**ENMAX Power Corporation**

**101 Street Transmission Line 138-7.82L Relocation Project**

Decision 24828-D01-2020

Proceeding 24828

Figure 1: Proposed transmission line relocation<sup>4</sup>

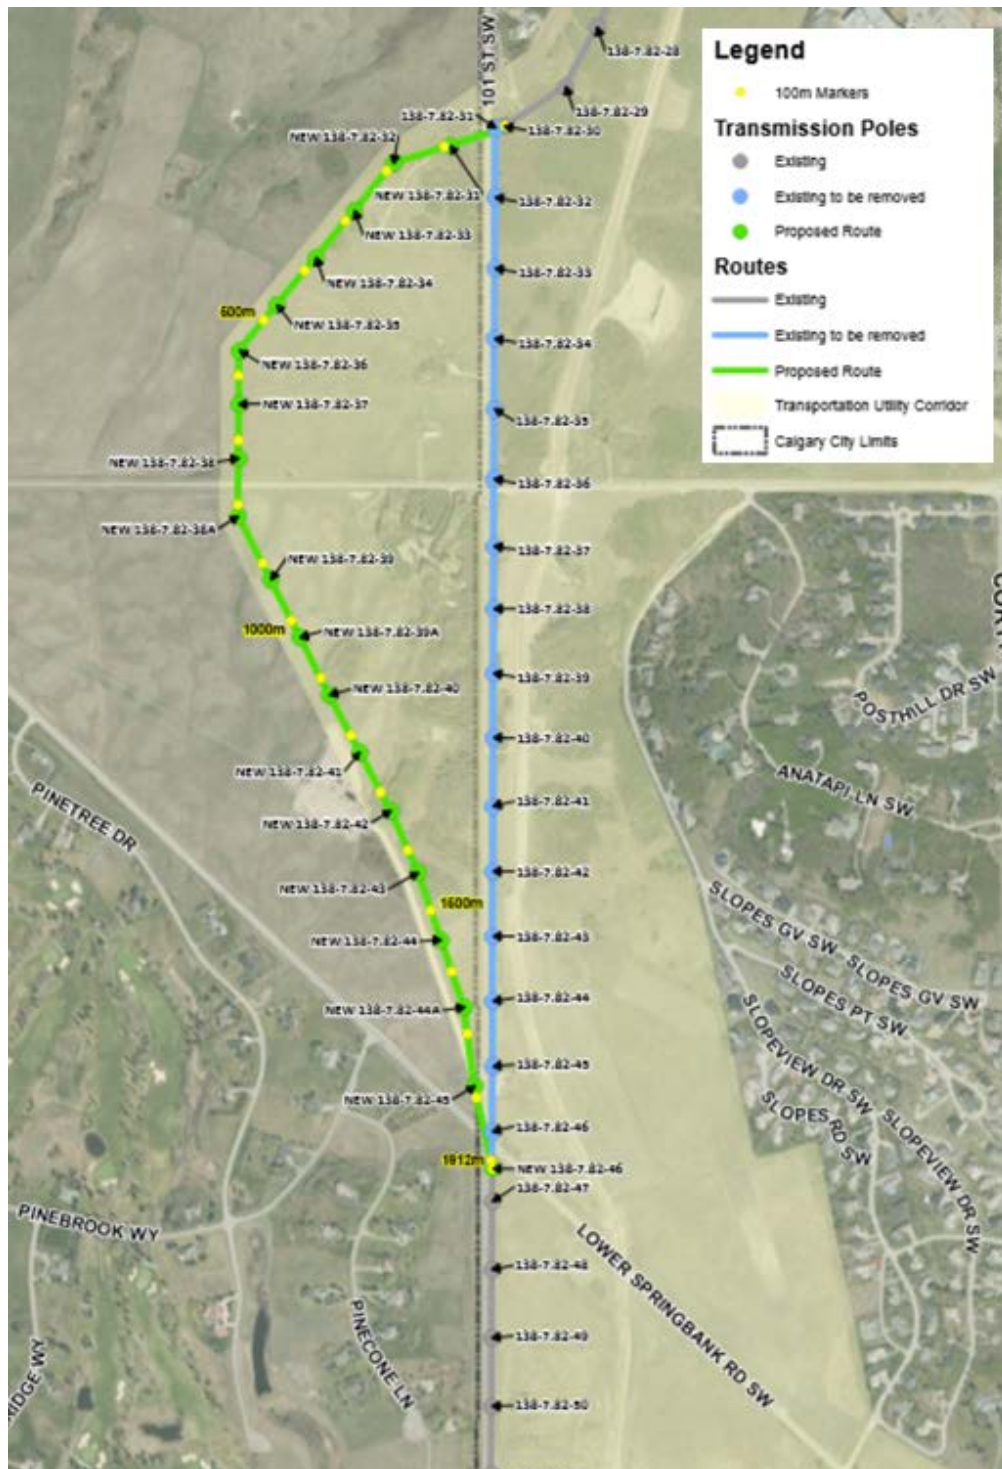
5. More specifically, ENMAX seeks approval to remove 17 existing wood poles (shown in blue as poles 30 to 46 in Figure 1 below), construct approximately two kilometres of overhead single-circuit 138-kV line, and install 20 new single-circuit self-supporting steel monopoles, also shown in Figure 1.<sup>2</sup> The proposed new structures range in height from 18 to 31 metres, while the existing wood poles range from 16 to 25 metres. As a result, there would be an increase in the height of the poles.
